FIELD INSPECTION

Project Name:	Mountain Valley Pipeline	Inspector:	Matthew Grant
Inspection Date:	Wednesday, September 26, 2018	Project Contact:	Brian Clauto
Spread: Franklin County	Spread I	Weather (Wet/Dry/Rain):	Wet

FIELD INSPECTION PHOTO LOG

Fig. 3
St#140009+00 ECD requires maintenance

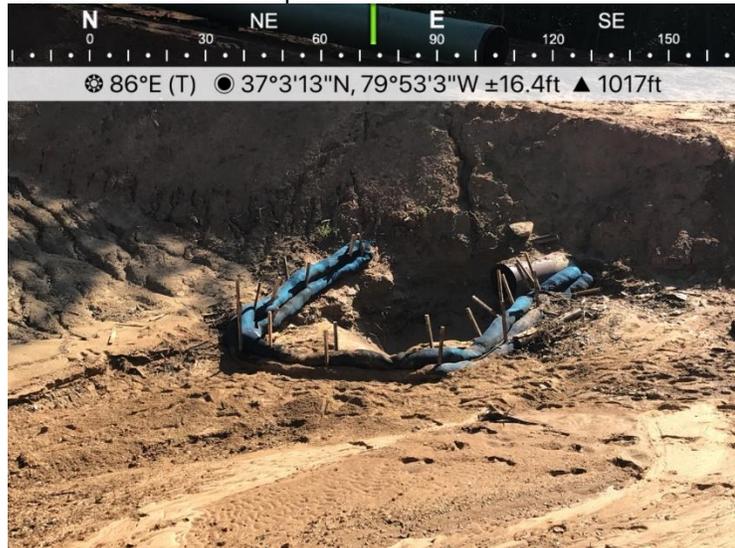
- **Area 1** – MP 265 St#14000+09 crews on site removing sediment off ROW
- **Area 2** - MP 265 St#14000+09 ECD requires maintenance

Deadline: Within 24hr notification
